UNITED STATES PATENT AND TRADEMARK OFFICE

APPLICATION NO.	FILING DATE	FIRST NAMED INVENTOR	ATTORNEY DOCKET NO.	CONFIRMATION NO.
09/935,869	08/23/2001	Jose Garcia Arumi	ARUMI	9449
7590 11/16/2004				
Ursula B. Day 350 Fifth Avenue, Suite 3220 New York, NY 10118				
			EXAMINER BAXTER, JESSICA R	
			ART UNIT 3731	PAPER NUMBER
DATE MAILED: 11/16/2004

Office Action Summary

DETAILED ACTION

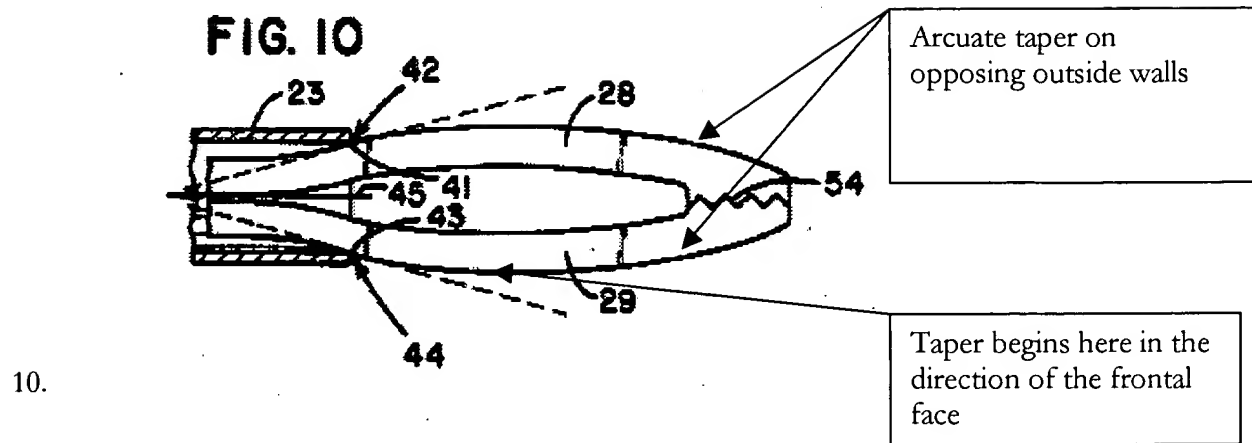
9. Applicant argues that the device disclosed by Sharpe et al. '973 does not disclose tapering arms as claimed by applicant. Applicant claims, "wherein the two arms starting from the cylindrical rod in the direction of the frontal face of the head piece when laterally viewed are tapered off with opposing outside walls of the taper configured in one of a straight or arcuate shape." The attached figure 10, clearly indicates how this claim limitation is met.
